item	section	edits
1	1.1	Please explain or define informative.
2	2.1©	<del>(c) any CABLING on the CARRIER'S side of the NETWORK BOUNDARY whether or not such CABLING is located in CUSTOMER PREMISES, e.g. LEAD-IN CABLING.</del>
3	2.6	<del>.In the performance of any cabling work, in general the</del> The cabling provider should ensure that.
4	2.6	The cabling provider <del>should</del> shall ensure that
5	2.7	<del>'... and to minimise the risk of crosstalk and adverse influences between ... '</del>
6	2.9 (g)	suggest replacing 'other workers' with 'ordinary persons'
7	2.9 (k)	suggest the replacement of 'ordinary persons' with `all persons`
8		suggest the insertion of `accessible` as a definition ... <i>capable of being reached for inspection, maintenance or repairs, but does not include destructive dismantling of structural components.</i>
9	4.2.4	' ... a wire or <del>strengthened</del> strength member that is ...'

comment	assessor
Suggest that 'informative and 'recommended ' are entered into the definitions, as this is being wrongly interpreted by engineers and techs as 'informative' as not being necessary to know	Lindon Haigh
Suggested deletion. This standard refers to 'carrier' alth

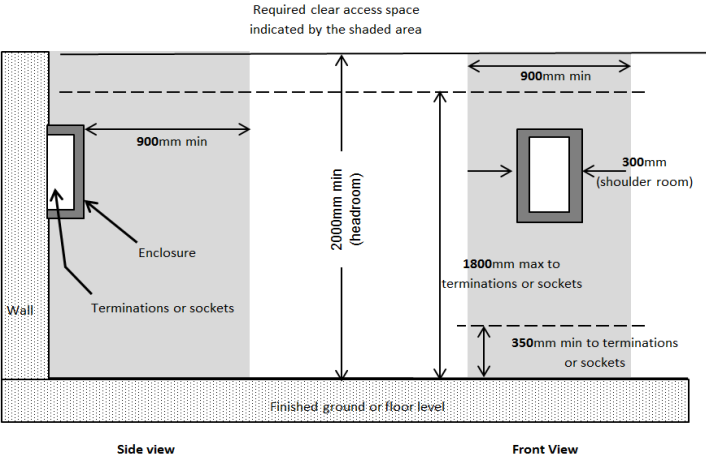
<p>New drawings being submitted that are more to scale. These drawings have caused many issues in the field . This drawing incorporates figure D3</p>	<p>Lindon Haigh</p>
<p>Reflects update in AS3000. A new drawing will be offered</p>	<p>Lindon Haigh</p>
<p>Edited for clarity. Confusing to read initially</p>	<p>Lindon Haigh</p>
<p>Suggested inclusion as many assume that FO has no conductive arts.</p>	<p>Lindon Haigh</p>
<p>Technical insertion as there is a distinct difference between hazard zone and zone.</p>	<p>Lindon Haigh</p>
<p>Industry jargon that concurs with AS/NZS 3835.1 &amp; .2</p>	<p>Lindon Haigh</p>
<p>Suggest inclusion of the following section to briefly describe the EPR hazards.</p>	<p>Lindon Haigh</p>
<p></p>	<p>Lindon Haigh</p>
<p></p>	<p>Lindon Haigh</p>
<p></p>	<p>Lindon Haigh</p>
<p></p>	<p>Lindon Haigh</p>
<p></p>	<p>Lindon Haigh</p>
<p></p>	<p>Lindon Haigh</p>
<p></p>	<p>Lindon Haigh</p>
